Nelson - Richmond Combined Structure Plan

Boffa Miskell Ltd has engaged Tonkin & Taylor to assist with the engineering and environmental aspects associated with the development of a combined structure plan for the Nelson – Richmond area. This letter report summarises the findings of our preliminary assessment into the environmental and engineering matters associated with development of the structure plan area.

BOFFA MISKELL
 RICHMOND-NELSON STRUCTURE PLAN
 water supply

FIG. No. **Map 1**

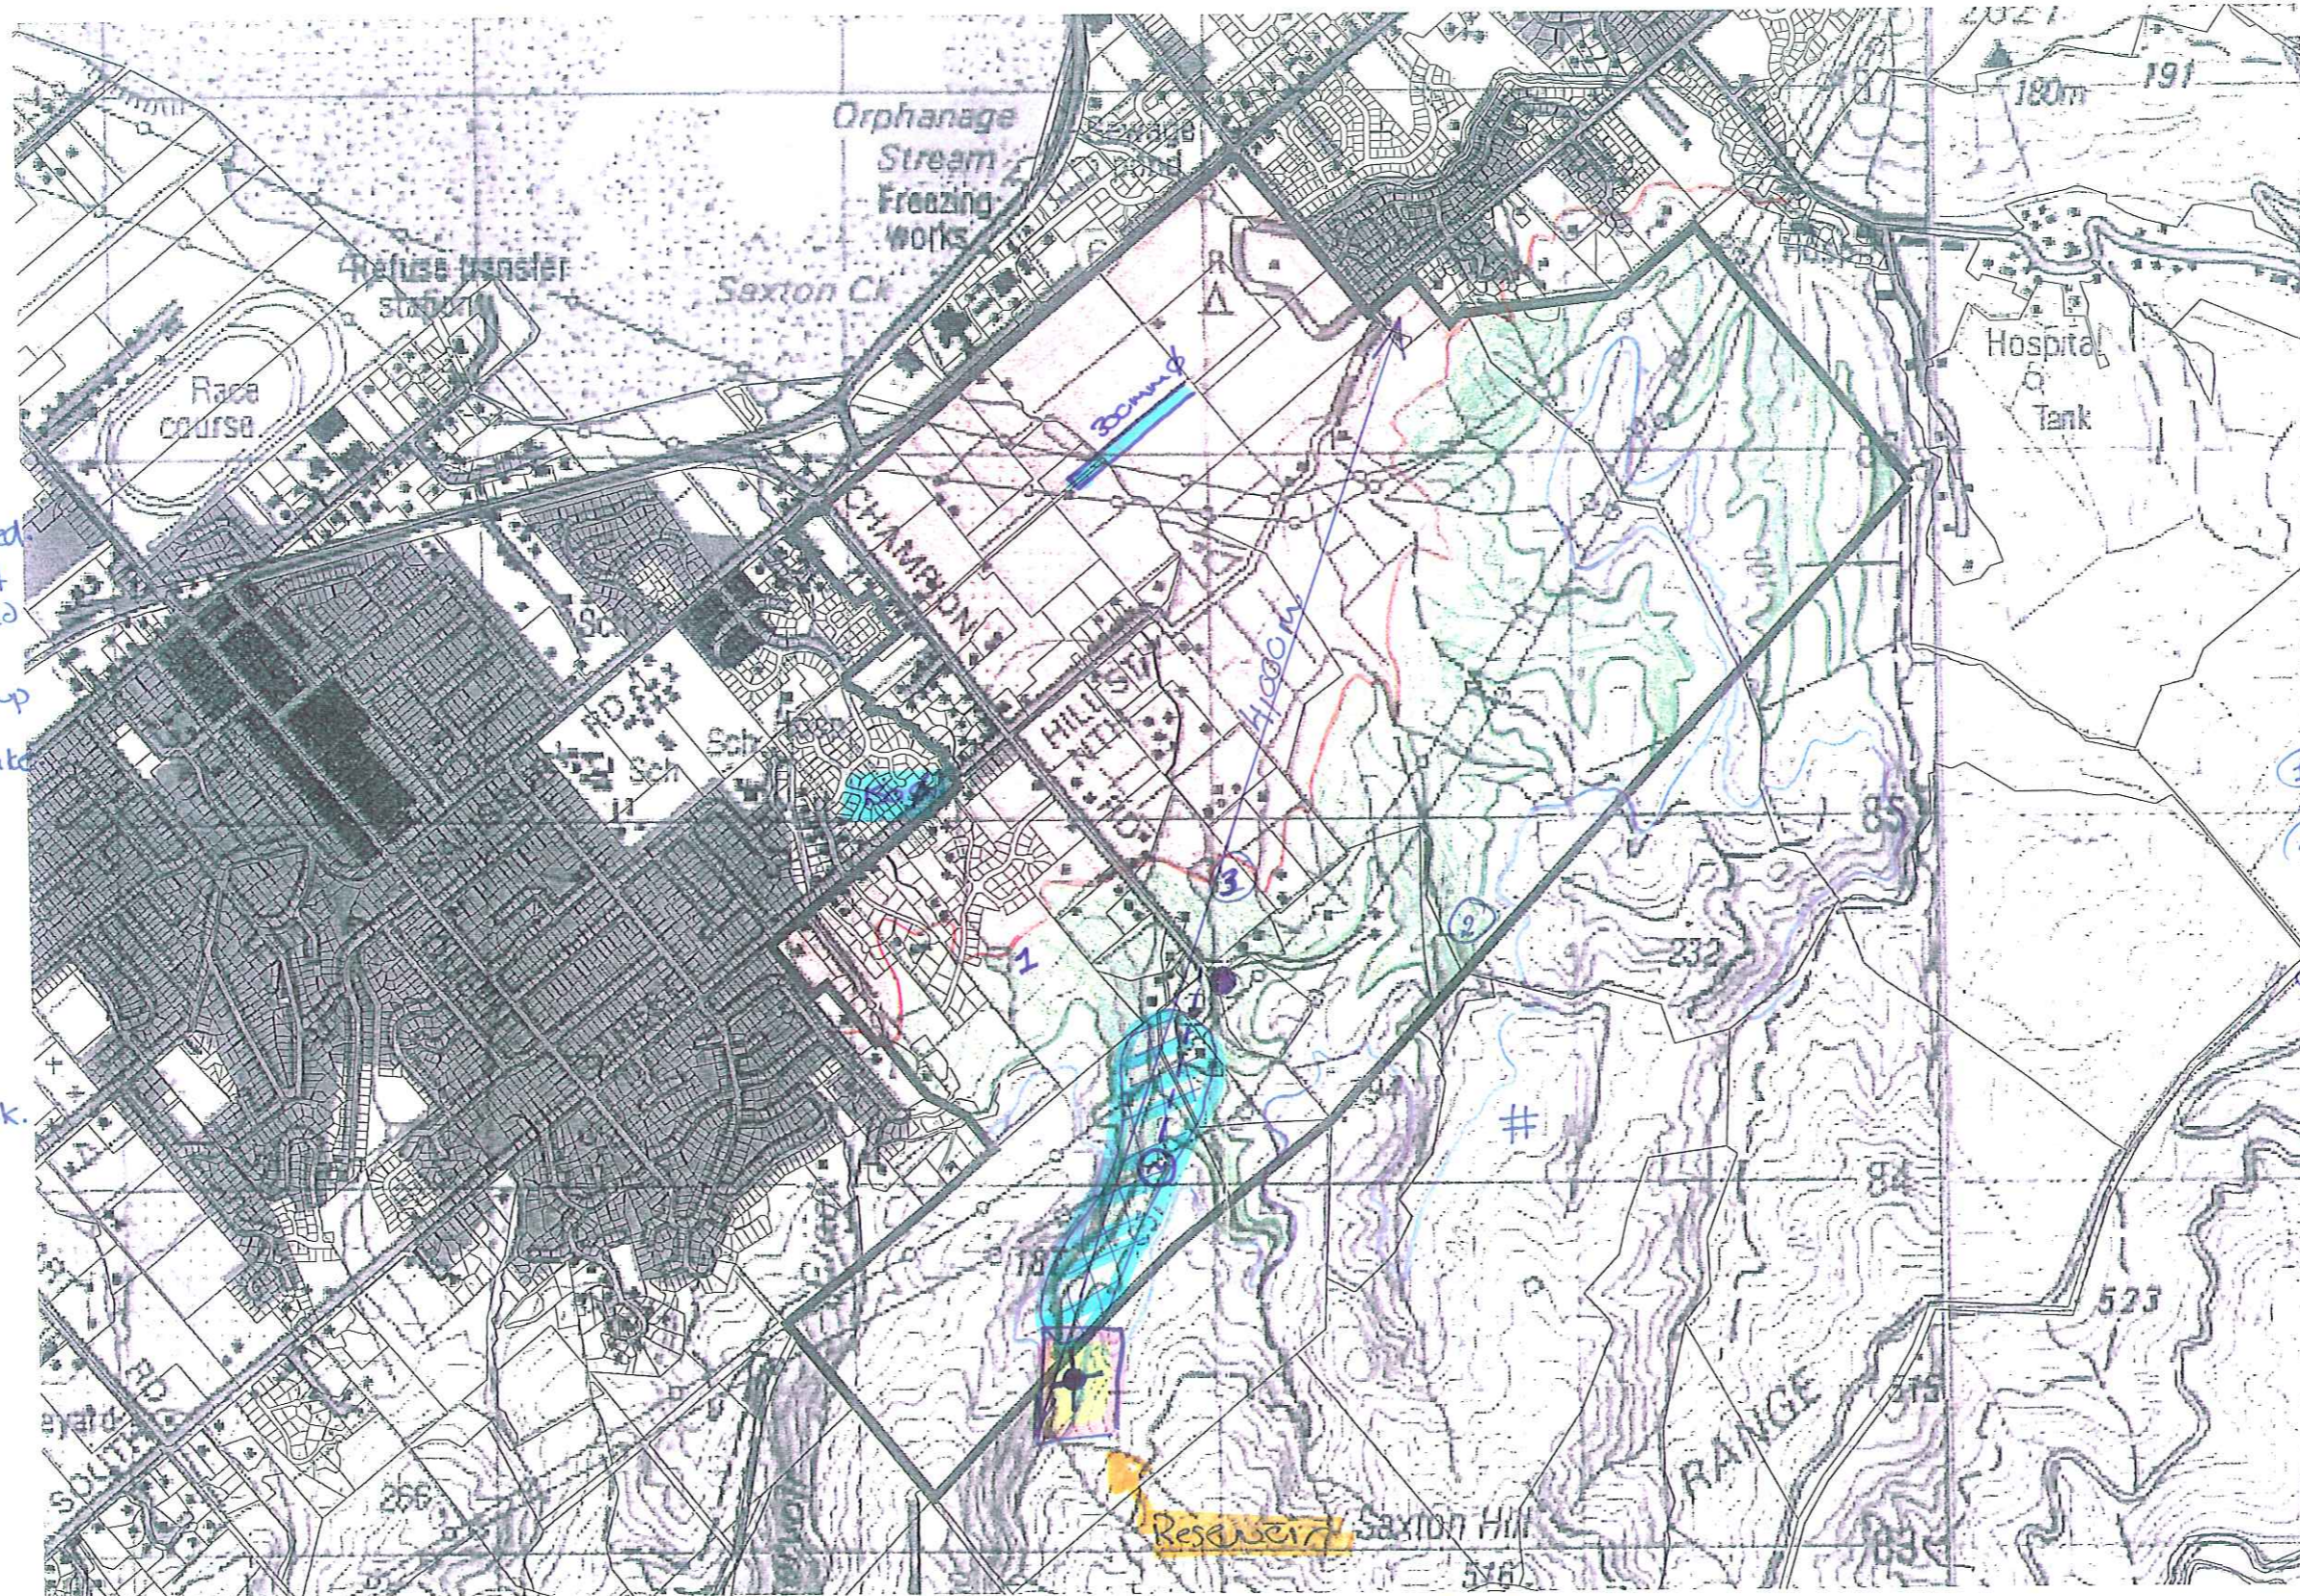
NCC comment:
 Upgraded A1
 Option preferred.
 - avoids fault
 - " restricted
 build
 - provide backup
 wrt fault
 rupture / Equate
 ⊕ to supply
 SP area.
 w/water
 300mm φ
 to wahanga
 details to check.

TDC
 No supply.
 Opt A upgrade
 A1 serve ⊕
 B serve SP #
 Area:
 1m³/household
 24 hr storage.
 # could be located
 along forestry
 access road (put)

- ① Dunstan Dam to go
- ② Raine Dam
 - increase risk
 - inspected +
 assessed.
- ③ Rick Giffen dam.

w/water
 Growth area OK to
 service 54.6 ha.
 area may
 req pls 2m
 + transition to gravity
 Main to service.

Map 2

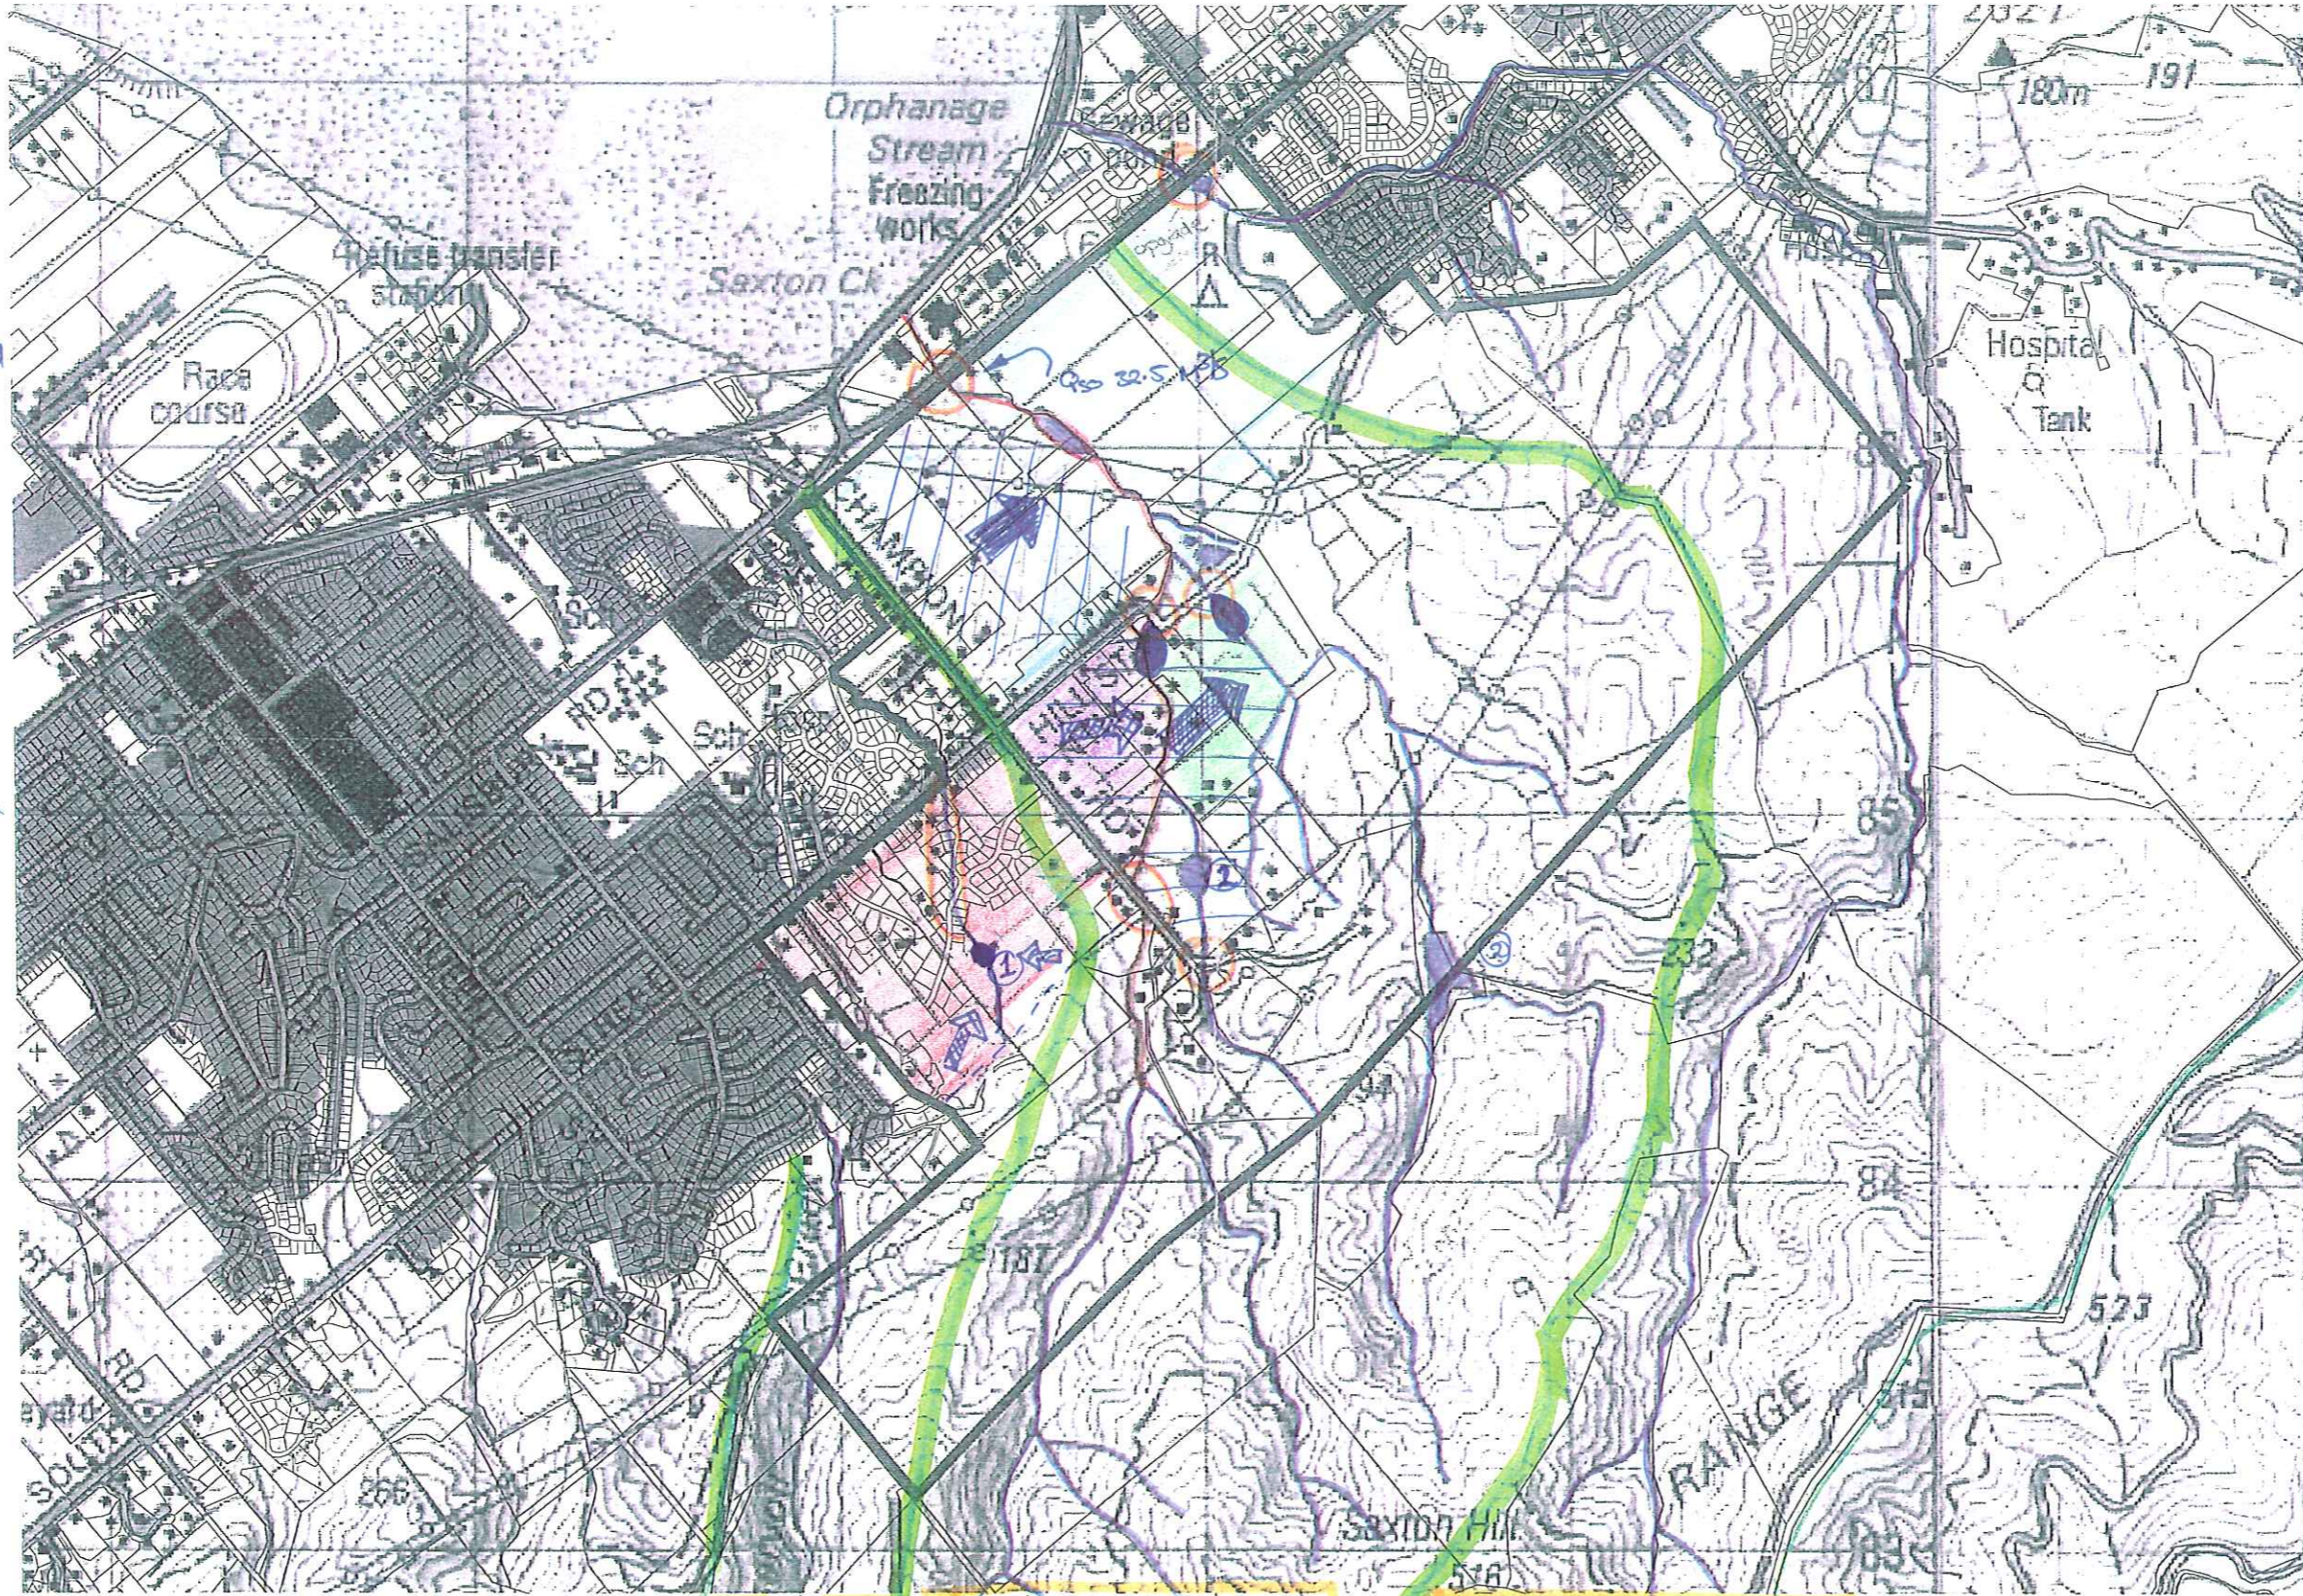
NCC:
Saxton Creek
culvert not
being upgraded

Orphanage St
upgraded +
cycle way.

Agreed that:
Saxton field pond
manage land
Mk Hill St
land str Hill St
need to be managed
on-site.

NCC:
TDE to
upgrade
Champion
Road.

- H2o + sewer
Existing Pans
- ① Filled-in
 - ② Assess wrt
Building Act.
 - ③ Assess wrt
Building Act

Saxton Catchment
67ha res had to
be ~~relocated~~ Saxton Creek.
Boffa
of 474 rural
122 res
596 ha total

upgrade irrigation
pond
possible ulstream effects.
